Access Compliance Report Public Rights-of-Way (Curb Ramps)

Intersection ID: N/A	Main Street: RIDGE_OAK_DR	Cross Street: OVERCUP_LN	Location: NW
ADA ID: 3F12C511B052	Ramp Type: Perp	Initial Pass/Fail: Fail	Overall Compliance: No Severity Score: 18.75

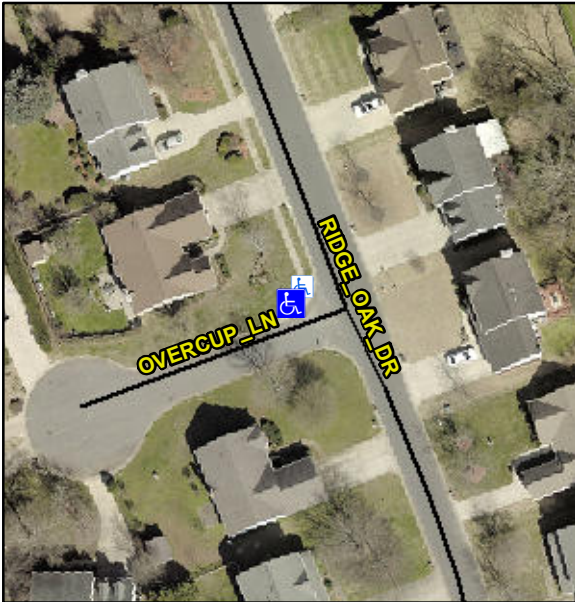
PROW/ADA:
R304.5.1, R304.5.3

Compliance	Description	Data	Compliance	Description	Data
N/A	Ramp Length (in)	95.0	Yes	Ramp Slope (%)	5.6
No	Ramp Width (in)	34.0	No	Ramp XSlope (%)	2.1
N/A	Flare Type LT	N/A	N/A	Flare Type RT	N/A
N/A	Flare Slope LT (%)	N/A	N/A	Flare Slope RT (%)	N/A
N/A	Flare Traversable LT?	N/A	N/A	Flare Traversable RT?	N/A
N/A	Landing Length (in)	N/A	N/A	DWS Provided?	N/A
N/A	Landing Width (in)	N/A	N/A	DWS Contrast?	N/A
N/A	Landing Slope (%)	N/A	N/A	DWS Length (in)	N/A
N/A	Landing X Slope (%)	N/A	N/A	DWS Full Width?	N/A
N/A	Landing Curb? (Y/N)	N/A	N/A	DWS Offset (in)	N/A
N/A	Shared Landing?	N/A			
N/A	Gutter Ponding?	N/A	N/A	Gutter Slope (%)	N/A
N/A	Gutter Lip Ht (in)	N/A	N/A	Gutter X Slope (%)	N/A
N/A	Painted X Walk1?	No	N/A	Painted X Walk2?	N/A
	X Walk 1 Direction	To S		X Walk 2 Direction	N/A
N/A	X Walk 1 Width (in)	N/A	N/A	X Walk 2 Width (in)	N/A
	X Walk 1 Slope (%)	0.6		X Walk 2 Slope (%)	N/A
	X Walk 1 X Slope (%)	0.3		X Walk 2 X Slope (%)	N/A

Possible Solutions:
Remove & Replace Entire Ramp.
